RE: COFA Submittal #3 – Big Blue Marble Academy Cypress Ridge

RE: Big Blue Marble Cypress Ridge – Planning Commission Comment Responses

BIG BLUE MARBLE ACADEMY

A 104

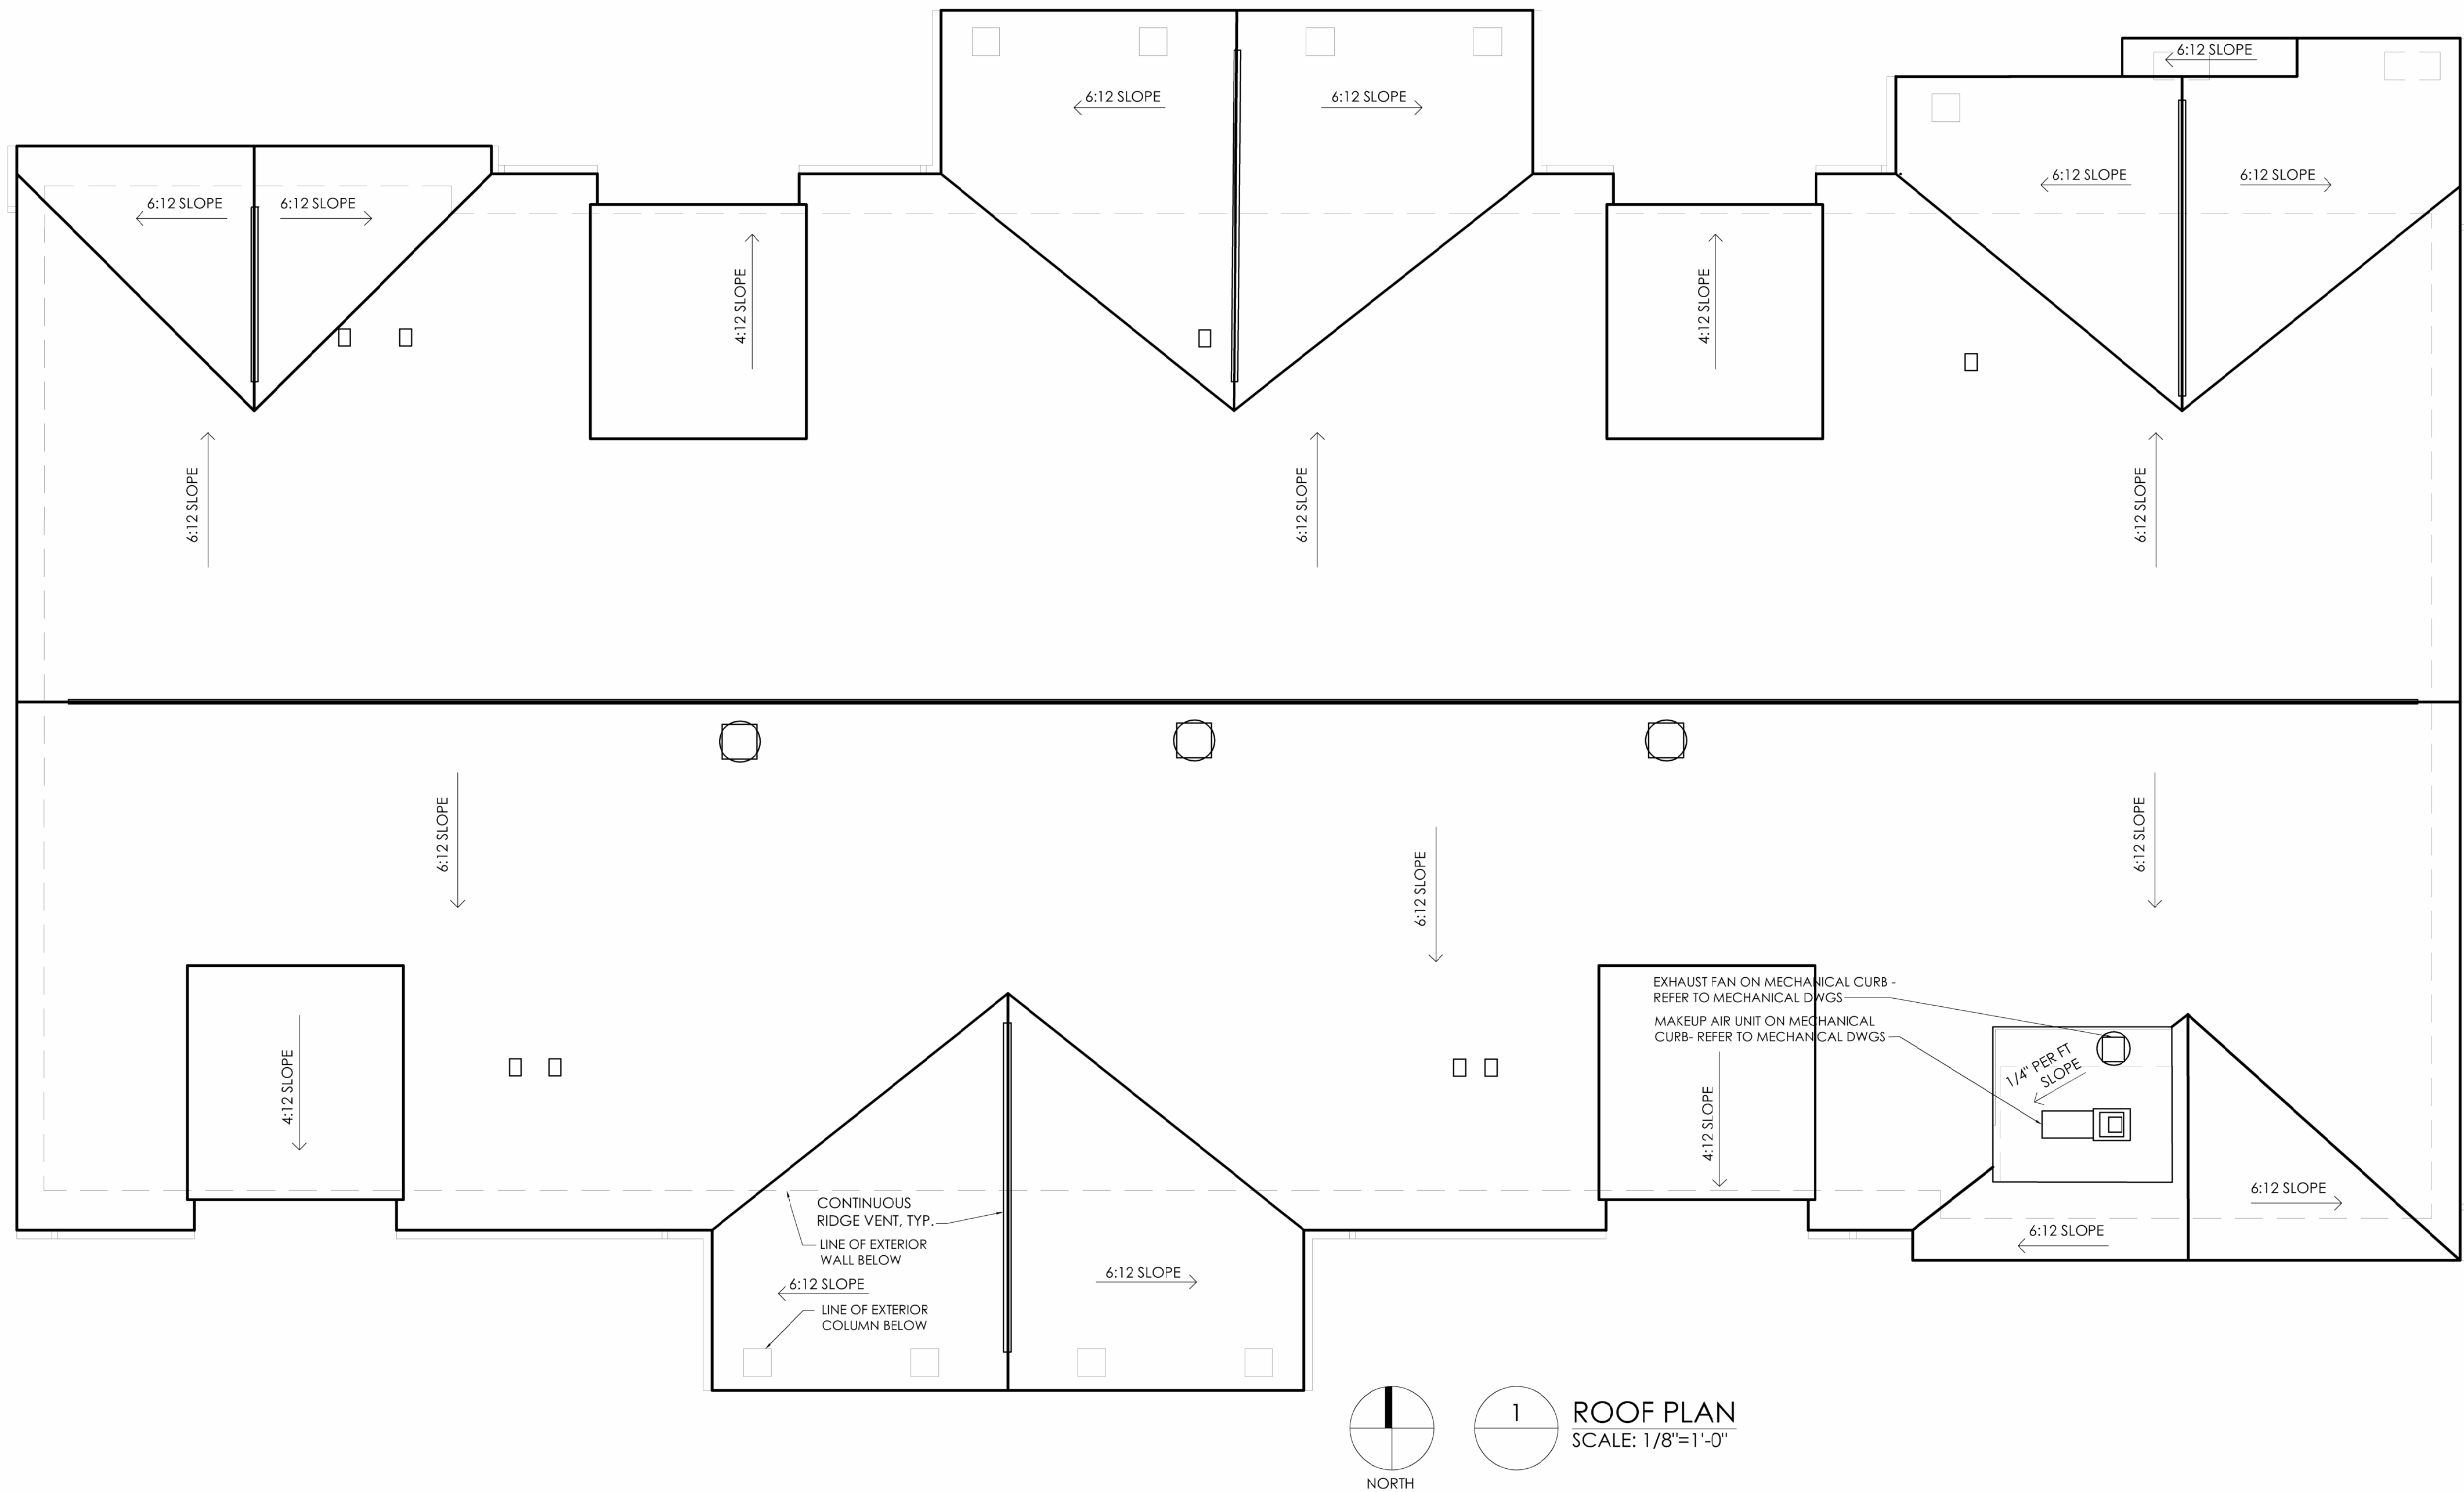
- a. Per Section 4.16.2.A. all roof mechanicals are shown on the front elevation, facing Highway 170, and must be revised.
 - Roof mechanicals have been inset into the roof line to provide screening from Highway 170. Review the 3D isometric view, "Roof Massing" to view the revised screening for the mechanical units.

A 201

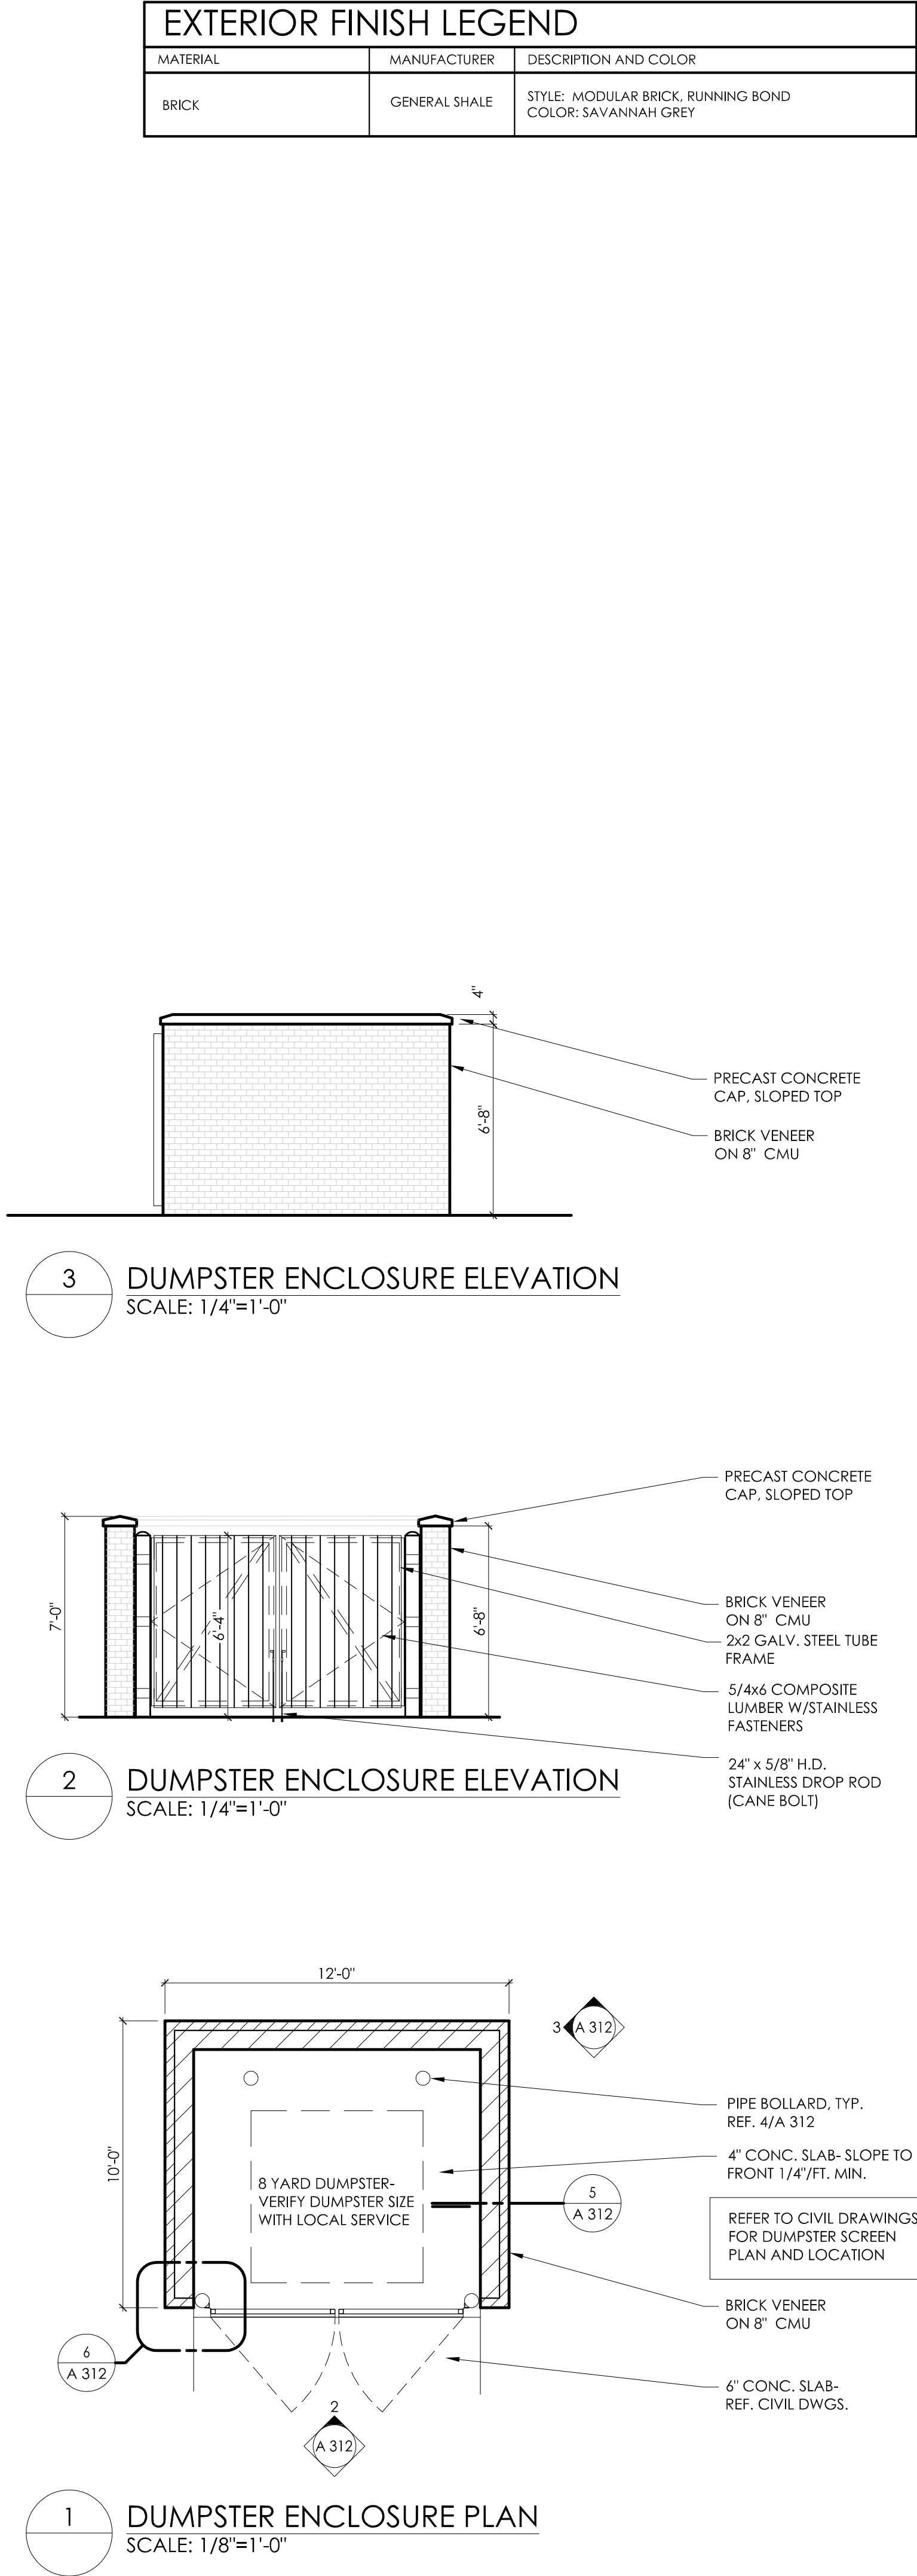
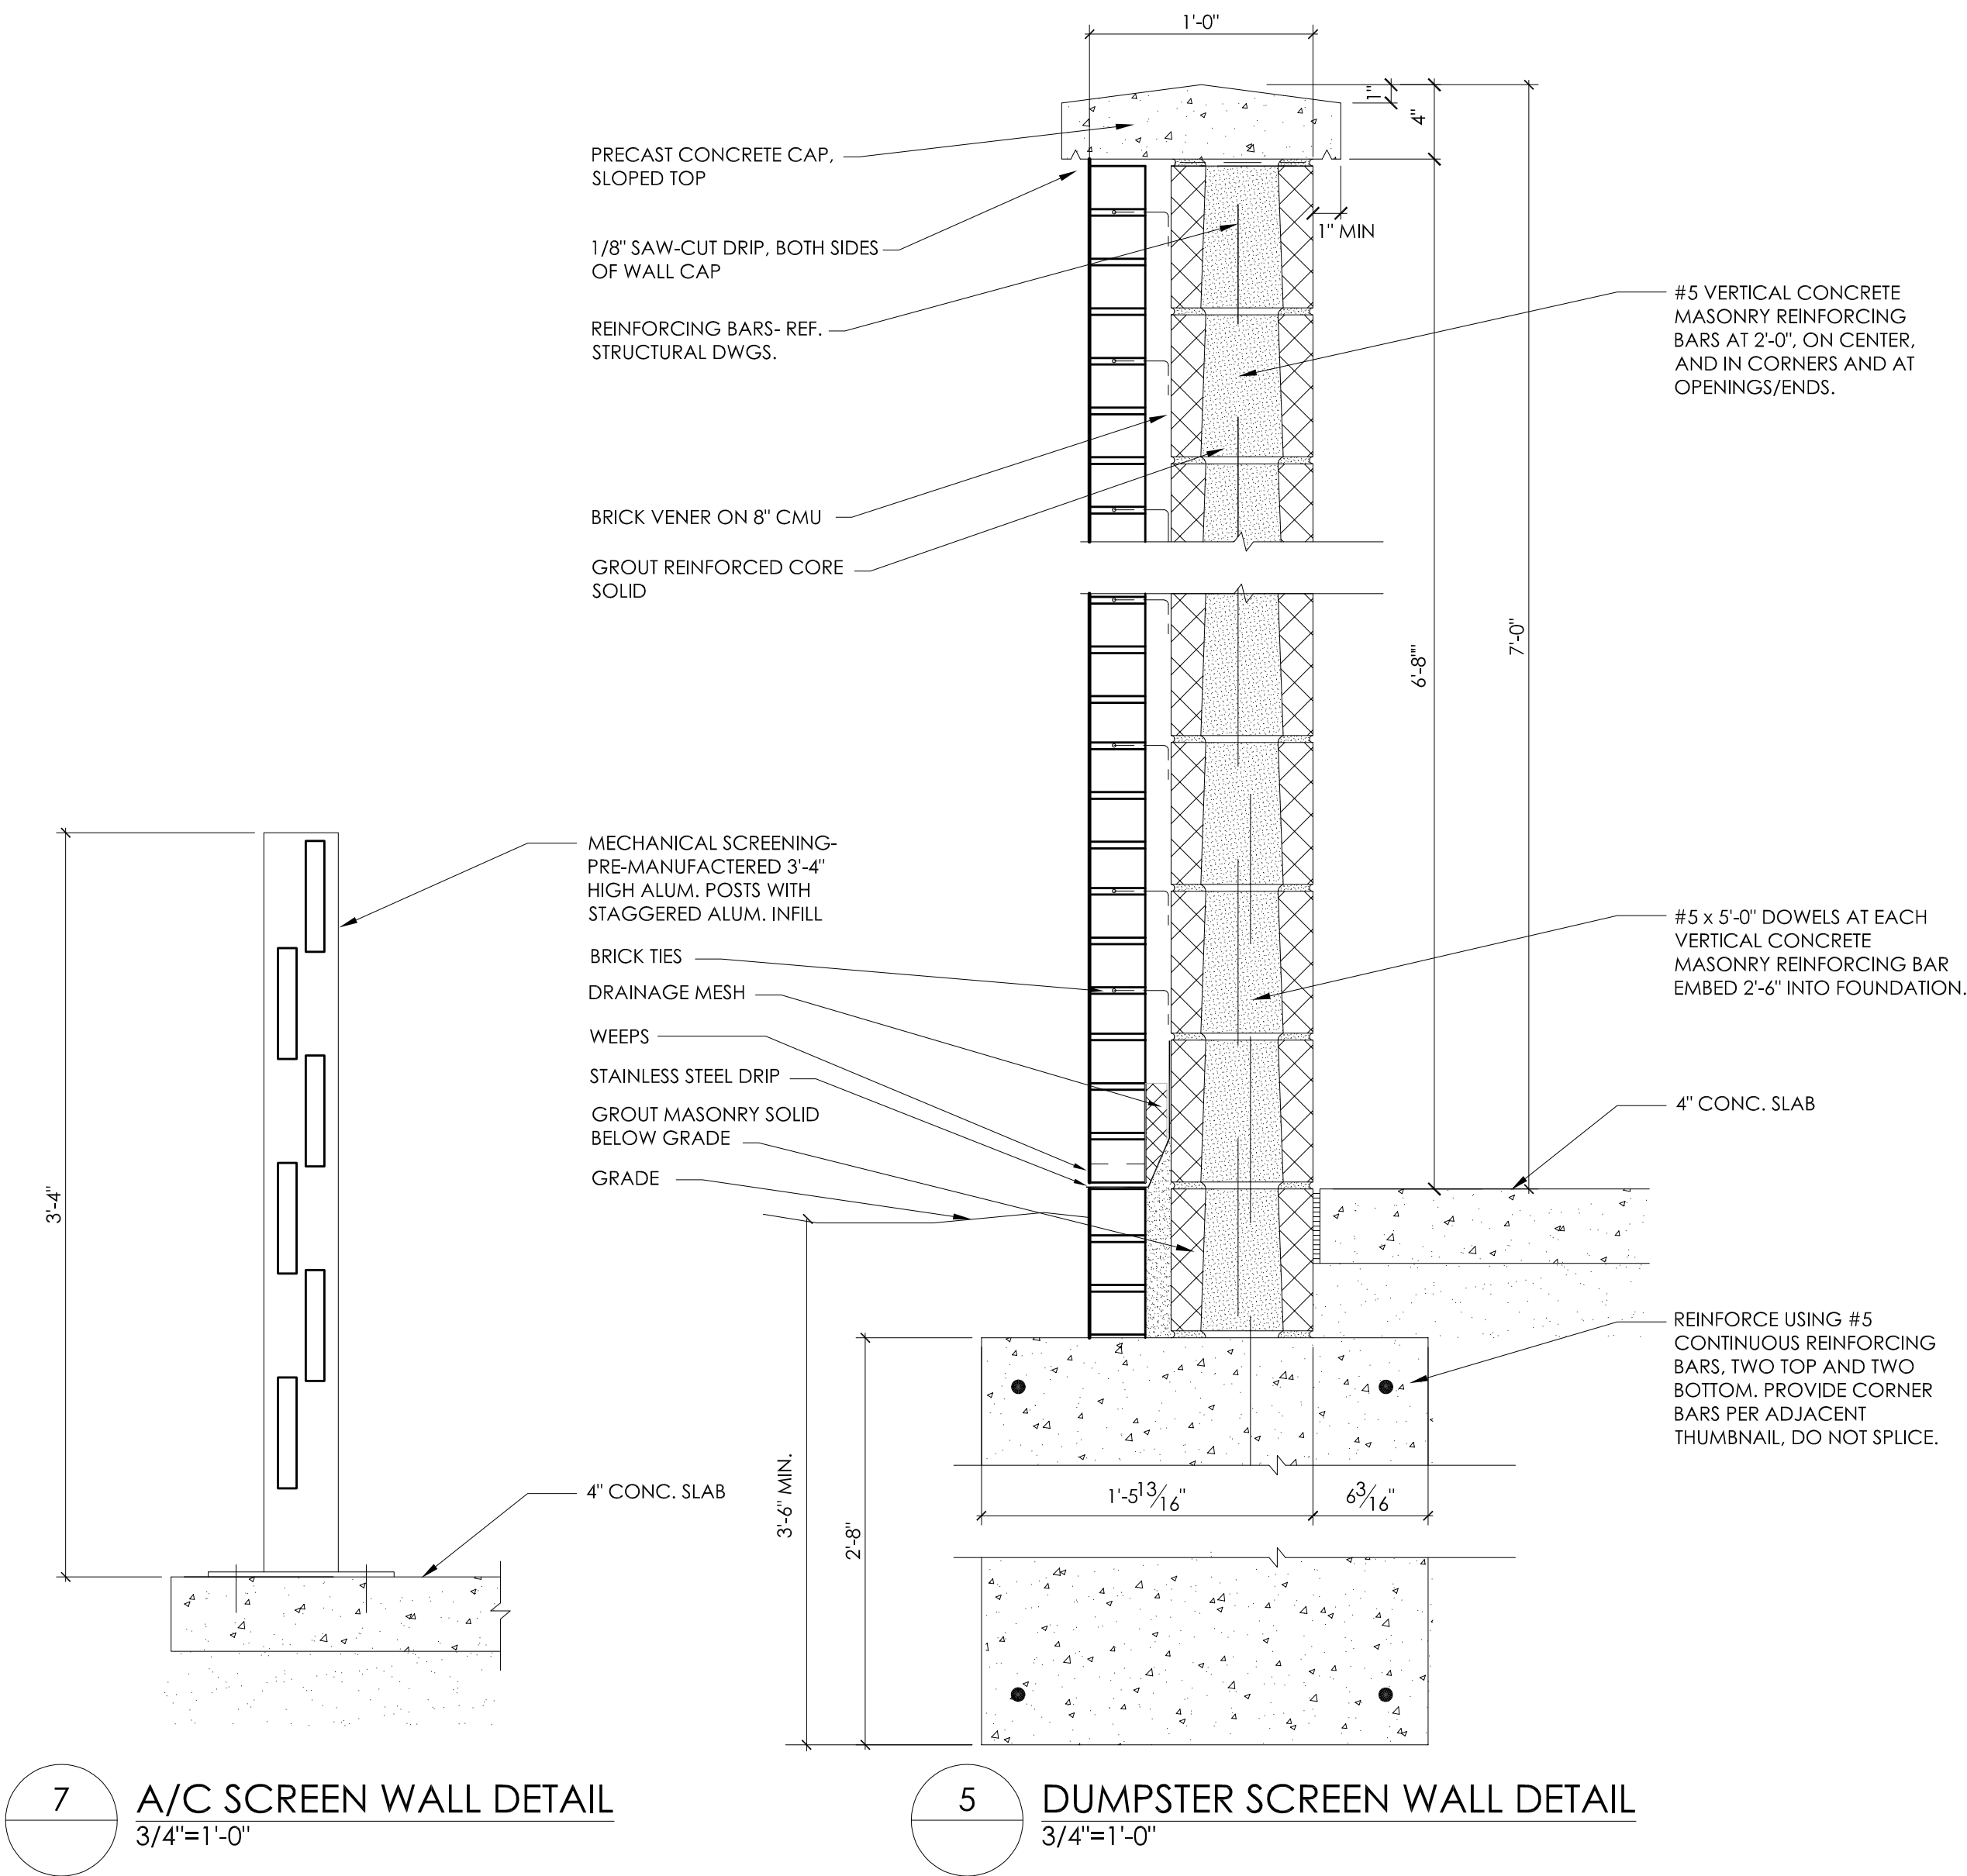
- The fence location has been updated everywhere so the area is passable while a door is open.
- g. Per Section 4.23.3.A., the dormers should be relocated to be centered over the elements beneath them. Roofs need to have a minimum 4:12 pitch. – Might consider increasing the pitch of the primary mass to 6:12 (recommendation not requirement, but the dormers will need to feel appropriate on the main mass)

- Accent roof pitches increased to 12:6. Main roof pitch increased to 12:4. Four dormers have been added.
- h. Per Section 4.23.3.A., the Front (Highway 170 facing) elevation should be reconsidered to better address the street.

- The south elevation has been revised to better address Highway 170. Additional dormers have been added and all mechanical units have been screened from the view of the highway. The south elevation (rear of building) has been designed to closely resemble the north elevation (entrance) of the building.

- The main entrance location has been mirrored/relocated to better accommodate the parking lot layout & improve circulation of the overall site.
 - j. Revise door lite pattern on rear elevation to match for consistency. Also take a look at the doors for the electric rooms on the front if they are to remain on that elevation as they appear as service doors – on the front elevation, which is problematic.

- Revised pattern & added additional door lights on rear elevation.
 - Revised the electric room doors on south elevation to match existing doors. Added spandrel glass to reduce visibility into the electric rooms.
